**FURTHER INFORMATION RESPONSE
TILE 3 - SDZ22A/0017**

**IN RESPECT OF A
PROPOSED RESIDENTIAL DEVELOPMENT AT
CLONBURRIS TILE 3
April 2023**

Client:	Cairn Homes Properties Ltd.
Project Title:	Tile 3 - SDZ22A/0017
Document Title:	Further Information Response

Figure 2.2 – Net Development Area

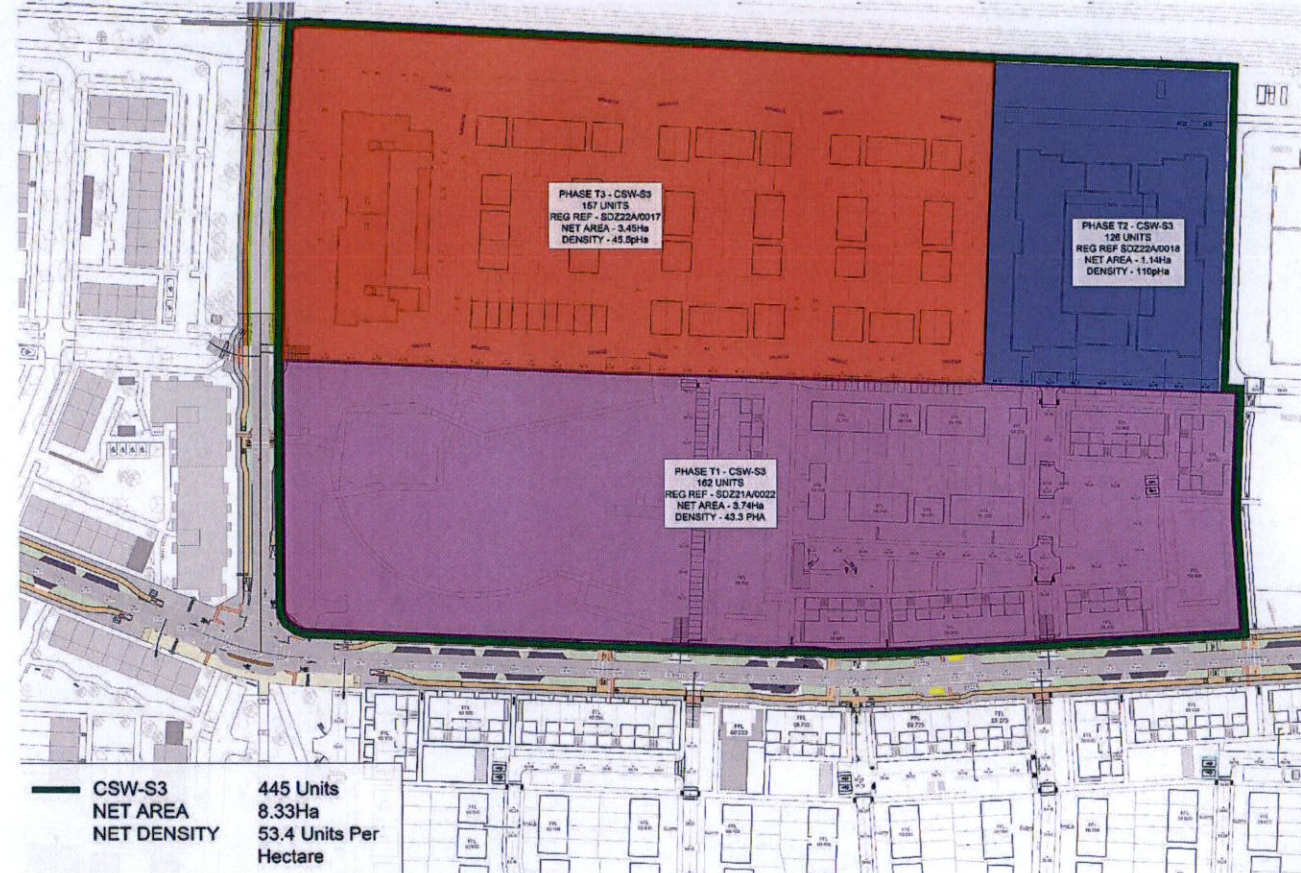
“The applicant is requested to detail how the total net development area for CSW-S3 is met through applications SDZ21A/0022, SDZ22A/0017 and SDZ22A/0018.”

In response to this item, the CSW S3 lands have been subject of 3 no. separate applications comprising Phase Tile 1 (SDZ21A/0022), Phase Tile 2 (SDZ22A/0018) and Phase Tile 3 (SDZ22A/0017) and comprise 8.33 hectares (net) in total.

Figure 4.1 – Clonburris Movement Concept

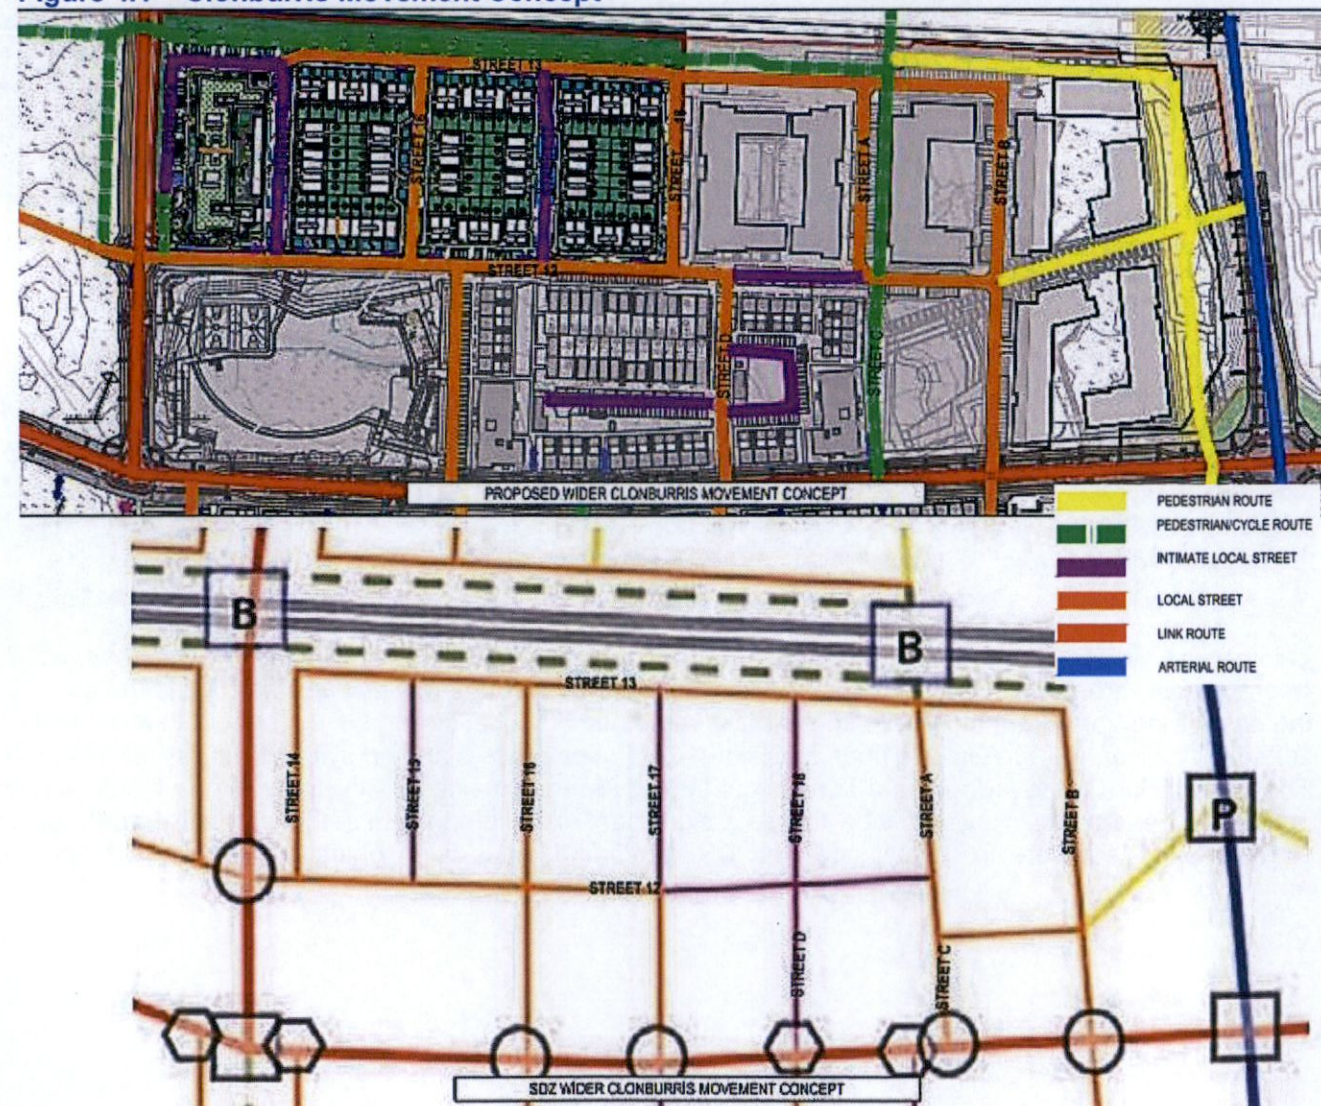
- Street 18: Generally meets indicative local street A (when considered with information provided on adjacent application). Scheme requires intimate local street at this location and the applicant is requested to provide a rationale for their approach.

In response to this item, we refer the Planning Authority to the DBFL response and movement concept drawing CLB-T3-95-SW-DTM-DR-DBFL-CE-1203 showing a comparison between the wider Clonburris proposed movement concept and the movement concept in the Clonburris SDZ.

The SDZ movement diagram indicates 4 Local Streets north of Street 12 and 3 Intimate Local Streets north of Street 12, matching the number of Street types proposed for the subject development based on Street hierarchy.

Figure 4.2 – Apartment Cycle Provision

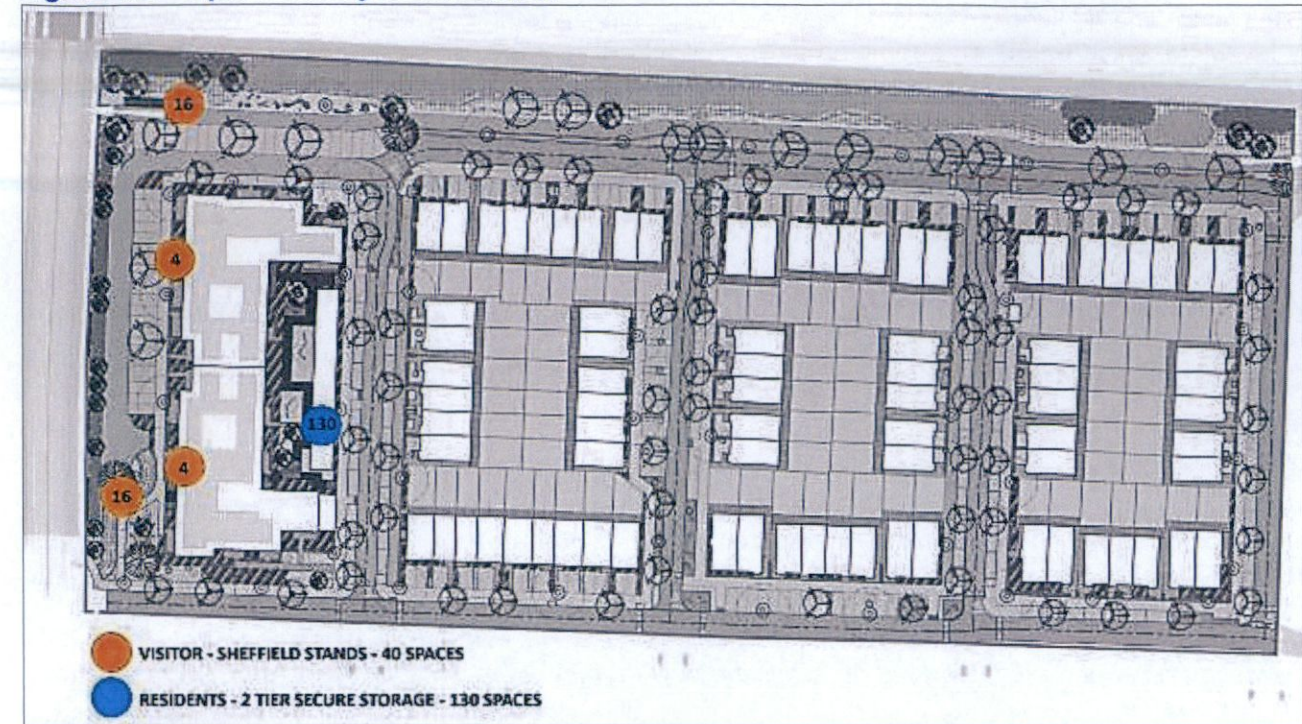
- "The applicant is requested to provide additional information which:*
- I. details all (any additional) bicycle parking locations within the site.*
- II. demonstrates the proposed number of spaces meets the minimum CDP 2022-28 criteria.*
- III. demonstrates there is significant capacity within the proposed bicycle parking store to cater for the proposed number of 170.*
- IV. acknowledges the proposal is in line with the National Cycle manual (2011).*
- V. gives additional detail re the bicycle stand specification (i.e., Sheffield stands) proposed."*

Additional visitor bike stands have been added adjacent each apartment block entrance and along the cycle lanes to achieve a total no. of 20 stand for 40 visitor bikes. See drawing 22234-1-100 (LANDSCAPE Masterplan), prepared by CSR which shows the locations. The extract below also shows the long term and visitor parking in the vicinity of the apartment building.

Figure 5.1 – Parking Plan

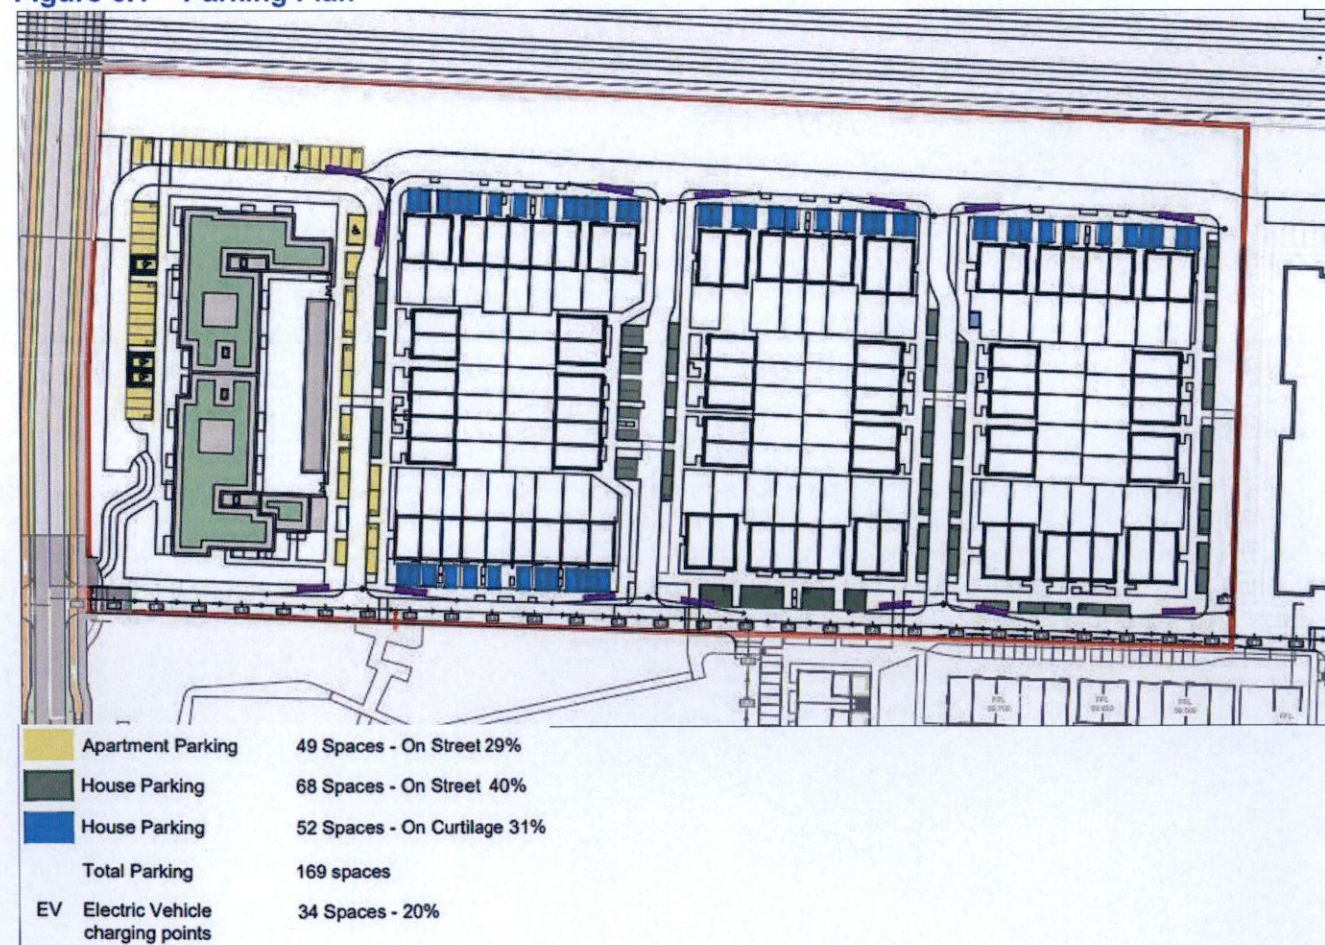
The design statement states that 38% of car parking is on curtilage. The applicant is requested to provide a plan indicating which spaces are on curtilage and which are off curtilage”

In response to this item, A revised parking plan which incorporates changes to the site layout and identifies on curtilage and on street parking has been submitted as part of the Further Information drawing pack. For further details, please refer to PL008 Parking Strategy Rev A. Parking classification is as follows:

- House parking - on Curtilage - 52 spaces - 31%
- House parking - on Street - 68 spaces - 40%
- Apartment Parking - on Street- 49 spaces - 29%
- Total parking 169 spaces

Figure 6.3 – CGI from under future bridge looking towards Block 1

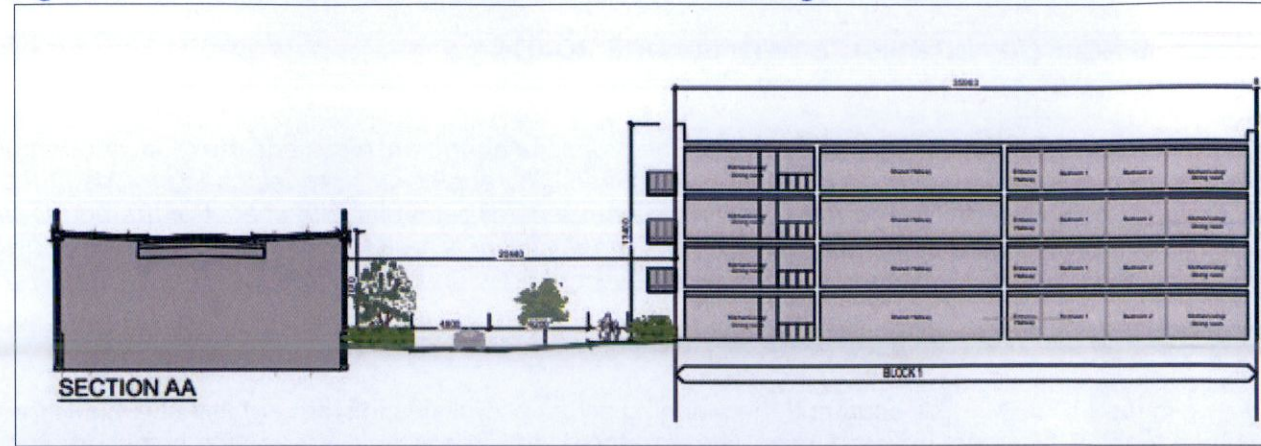
“There is concern regarding the interface between the proposed apartment block and the roadway / bridge to the west. Further consideration of this matter is required. The applicant is requested to provide further cross sections to include the bridge and also provide more detail regarding the impact of the bridge on the amenity area to the west of the apartment block. The applicant is requested to provide details of how any retaining features may be incorporated into the adjacent open space.”

As set out in the MCORM FIR Document, the planning scheme identifies this area of the SDZ lands for a vehicular bridge to cross over the existing rail line. It further identifies this as a location for avenue frontage as it recognises that a robust building line must be in place here to address the major piece of connecting infrastructure which will be constructed immediately to the west.

The revised proposal recognises that distance from the bridge, orientation and soft landscaping will have a positive impact on the amenity of future residents of the apartment block. The revisions to the site layout has increased the distance between the bridge and the apartment block and reduced or rearranged parking proposals allowing for increased, uninterrupted Green Infrastructure to be proposed along the bridge. While the bridge design itself will be the subject of a future planning application, the continuous strip of land which runs along the eastern side of the bridge crossing point has been set aside to incorporate any landscape or retaining features which may arise from the design of the bridge. While the amenity area to the west of the bridge is not the subject of this application, a similar approach will be taken there, with a larger area being retained for the amenity area identified in the planning scheme at that location. For further information relating to Bridge interface and separation distances, please refer to PL013 - Bridge and Apartment Block Sections.

Figure 7.1 – Surface Water Catchments

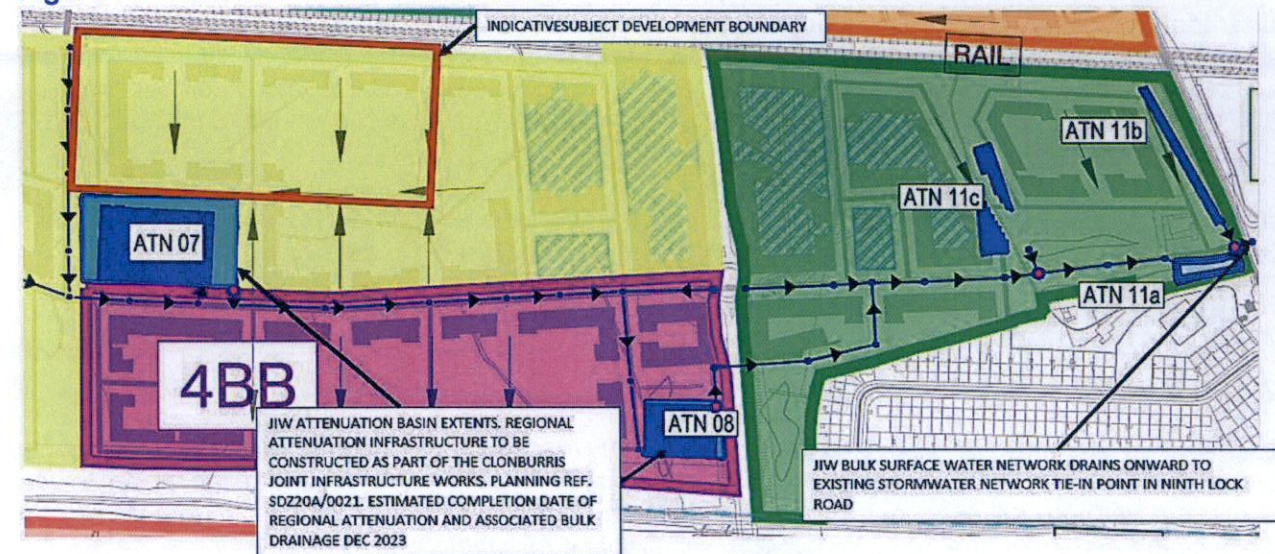
“Submit a report and drawing to show what attenuation was agreed for the site proposed and what attenuation is provided for the site proposed”

This shows that 1.87ha of impermeable area contribution from this sub-catchment (4B) has been assumed for regional attenuation sizing and only 1.815ha is proposed from the subject development, which means the development is well within the designed limits.

The figure below shows the overall drainage strategy for the wider Clonburris, which matches the downstream surface water drainage infrastructure provided with the adjacent Clonburris T1 development and the joint infrastructure bulk drainage under construction.
